# Appendix BJ: Strawbale Construction

July 15, 2025

### SIMONA FISCHER, AIA

FIGURE BJ105.1(1)—TYPICAL BASE OF PLASTERED STRAWBALE WALL ON CONCRETE SLAB AND FOOTING

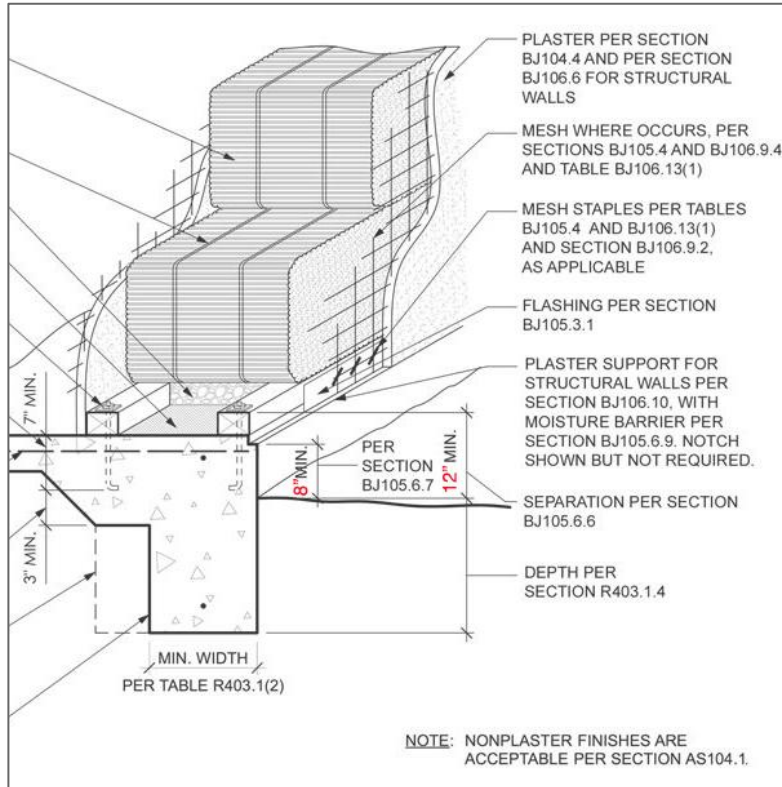
**BJ105.6.6 Separation of bales and earth.** Bales shall be separated from earth by not less than ~~8~~ 12 inches (~~203~~ 305 mm) in accordance with Figure BJ105.1(1).

**BJ105.6.7 Separation of exterior plaster and earth.** Exterior plaster applied to straw bales shall be located not less than ~~6~~ 8 inches (~~152~~ 203mm) above earth or ~~3~~ inches (76 152 mm) above paved areas in accordance with Figures BJ105.1(1) and BJ105.1(2).

- Increase separation of strawbale walls above grade and paving, greater than the minimum currently in Appendix BJ and for conventional wood-framed walls

FIGURE BJ105.1(4)—TYPICAL TOP OF POST-AND-BEAM WALL WITH PLASTERED STRAWBALE INFILL

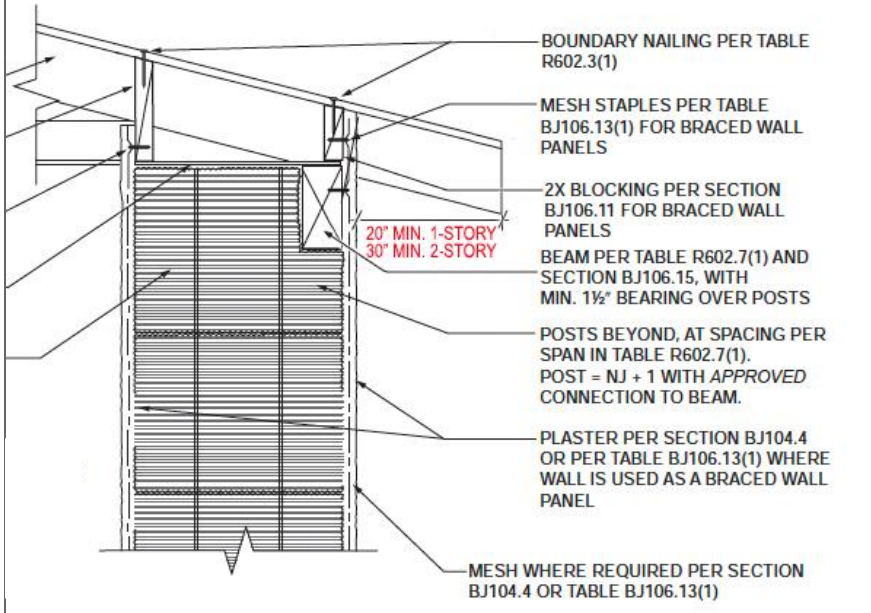
**BJ105.6.10 Roof overhangs.** Strawbale walls with direct-applied exterior plaster shall be provided with roof overhangs as follows:

1. 20" (508 mm) horizontal projection for one-story buildings
2. 30" (762 mm) horizontal projection for two-story buildings

Exception: Exterior strawbale walls with ventilated cladding in accordance with BJ104.1.1.

- Increased weather protection for strawbale walls, beyond conventional wood-framed walls which have no roof overhang requirement in the code
- Increases by 25% the recommended minimums of 16" and 24" provided by strawbale researcher John Straube / University of Waterloo in Ontario
